**2025 Court Improvements: James, Leahy, Ackerman, and Mason  
Parks**

**Bid # 25-24**

**ADDENDUM No. 1**

**April 16, 2025**

**A VINYL COATED CHAIN LINK FENCING**

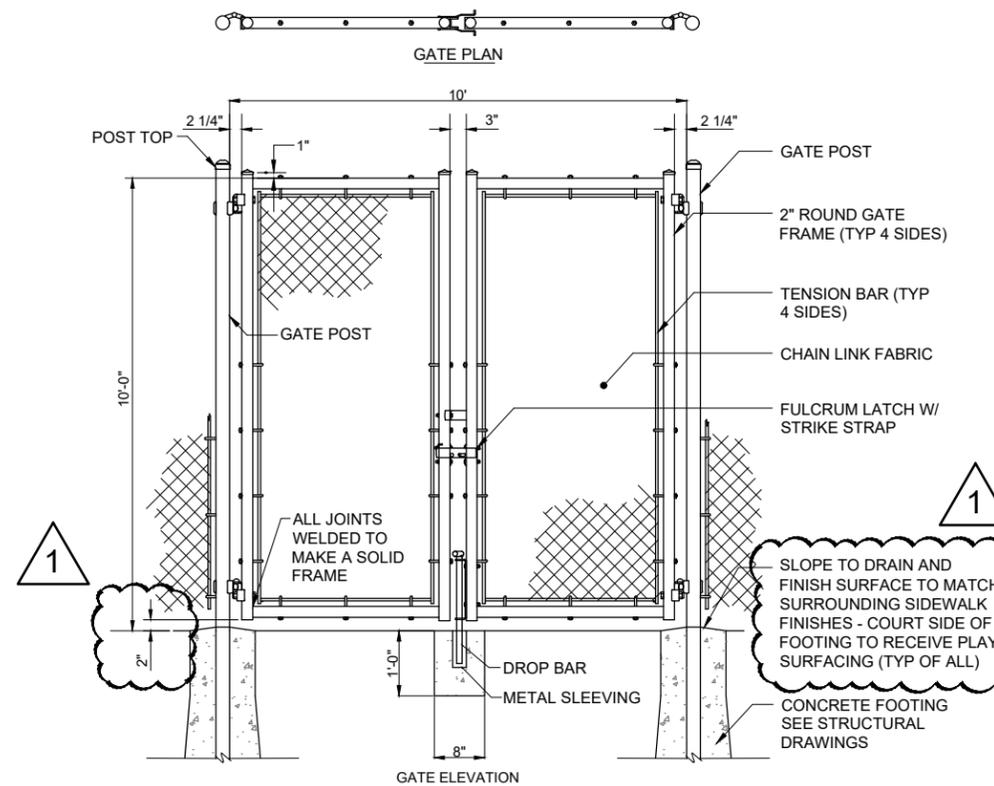
- Fence schedule updated on Detail A to reflect 2" pipe for top and center rail on 10'ht. fence.
- Foundation finishing notes added to Detail A, B, & C
- Conflicting dimension on base of Detail B updated
